September 20th, 2019

Re: Agnico Eagle's response to Meadowbank (2AM-MEA1526) Ground Water Monitoring Plan, Meadowbank Interim Closure and Reclamation Plan, Pore Water Quality Monitoring Program and Waste Rock-Tailings Management Plan comments

Figure 1: Location of the north-South cross-section with chloride plumes at t=20,000 years

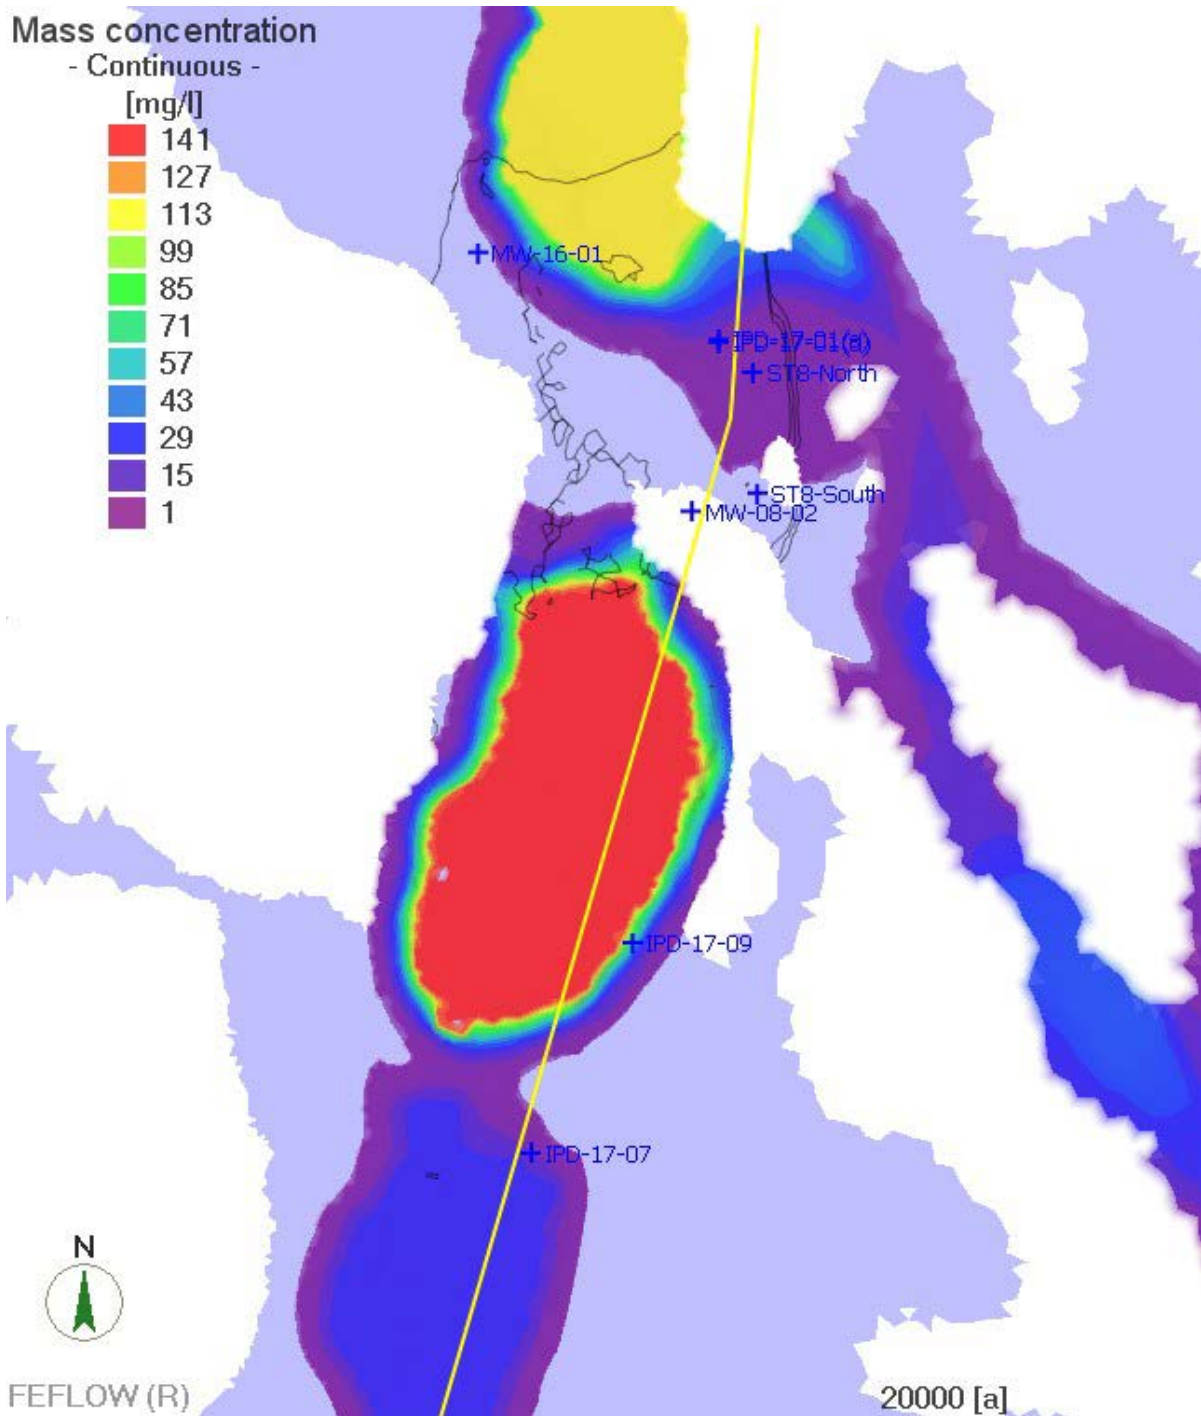
Recommendation 6: CIRNAC requests clarification on where the 3D model breakthrough curves predicted the highest chloride concentrations, and if the existing monitoring wells network intersects each of these predicted highest chloride concentration areas

In December 2018, the 3D hydrogeological model was updated (version 4) as per NRCan recommendations, and with their satisfaction. Even if it is challenging to have a clear 2D extraction of this modelling results, figures 1 and 2 below were produced to show predicted chloride plumes 20,000 years after pit flooding. Existing monitoring wells are also shown in the map and cross-section.

At Goose Pit, the MW-IPD-17-07 is aligned in the groundwater and plume pathway and screen depth allows to track the simulated chloride concentrations. At Pit E, the MW-IPD-17-09 is also aligned in plume pathway and its screen depth is close from the pit rim, allowing to intercept the simulated chloride plume.

At Pit A location, MW-IPD-17-01 is not perfectly aligned with predicted chloride plume (figure 1 and figure 2). However, as the location of the predicted plume is in the current permafrost area, it would not make sense to install any monitoring well in this area at this time. Monitoring of ground temperature during operation is required before installing any new well.
